Groundwater Application Review Summary Form

Application # ~~6~~- LL-1783

To: Kristopher Byrd, Well Construction and Compliance Section Manager
From: Joel Jeffery, Well Construction Program Coordinator
Subject: Review of Limited License Application LL-1783
Date: June 20, 2019

PUBLIC INTEREST REVIEW FOR GROUNDWATER APPLICATIONS

Theis drawdown at r=2000 ft from pumping well

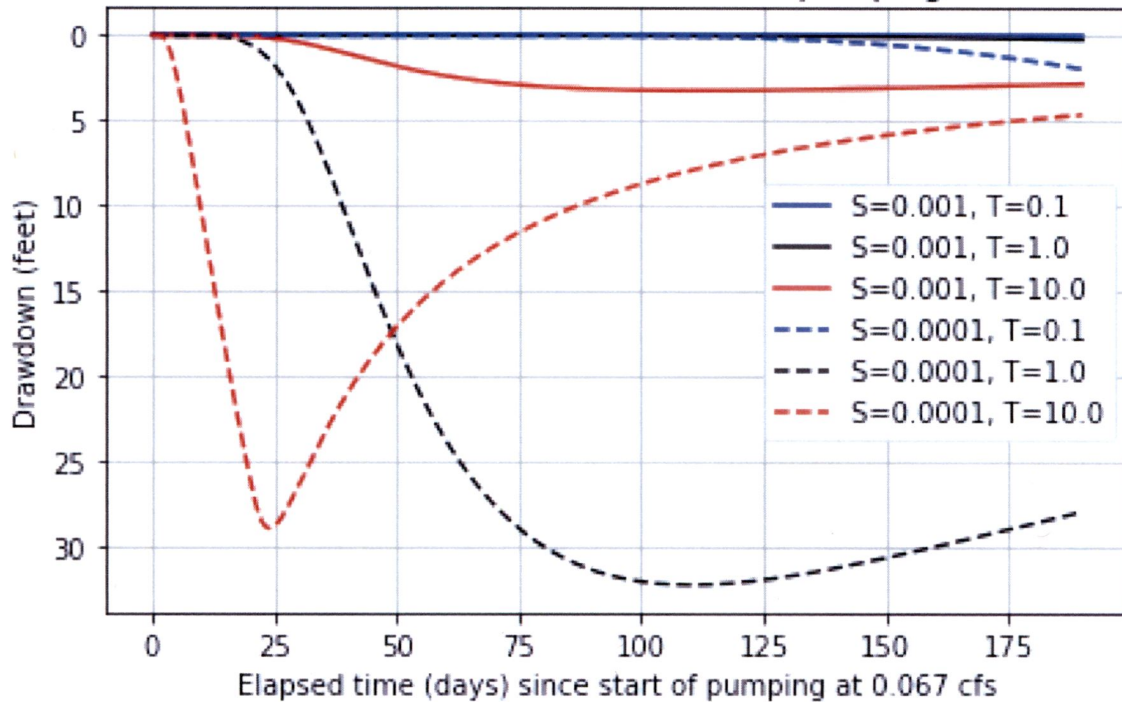
Limited water-level data show no evidence of long-term declines. Well density in the bedrock aquifer is relatively low, so impacts to other wells should be minor. However, there is a permitted spring with a certificated water right (Certificate 11154) within 1,700 ft of the subject wells and at an elevation consistent with their water levels. Analytic modeling using the Theis (1941) drawdown model with relevant parameters (Conlon, 2005; Domenico and Mifflin, 1965; Freeze and Cherry, 1979) suggests that pumping at the proposed rate for 19 days from the farthest well (Well #1, YAMH 704) would likely cause nearly 10 ft of drawdown at the spring (see figure below). Furthermore, the stream that originates at this spring is listed in the National Hydrography Dataset but not on the U.S. Geological Survey Quad map (revised 1993), suggesting that the spring is vulnerable to being dried up during some portion of the year (Geological Survey (U.S.), 2017). Therefore, the proposed use is likely to injure the spring right by causing a senior user not to receive their entitled water. Another permitted spring right exists within ~2,300 ft of the subject wells (Certificate 61841) and may also be injured by the proposed use. If the rate was reduced to 0.0039 cfs (1.75 gpm), the expected drawdown at the spring would be limited to less than 1 ft, such that injury would not be found (see figure below). In case a permit is issued, the conditions noted in B1(d) will enable monitoring for the protection of existing users against injury.

Spring injury modeling results

Pump on for 19 days, then off for the remainder of the modeling period. The top figure shows pumping at the requested rate of 0.067 cfs from Well #1 (YAMH 704, the most distant well), and the bottom figure shows pumping at 0.0039 cfs from Well #3, (YAMH57913, the closest well).

Comments: The requested rate exceeds 1% of the 80% Natural Flow in the Chehalem Creek WAB, so PSI was assumed for all the wells to SW #1. The finding of PSI would be reversed if the rate was set at or below 0.0039 cfs (1.8 gpm). Alternatively, the applicant could drill a new well on the property at a location outside of the Chehalem WAB, but such a well would necessarily be closer to the certificated spring (Cert 11154) such that the rate would need to be reduced somewhat to avoid injuring the spring.
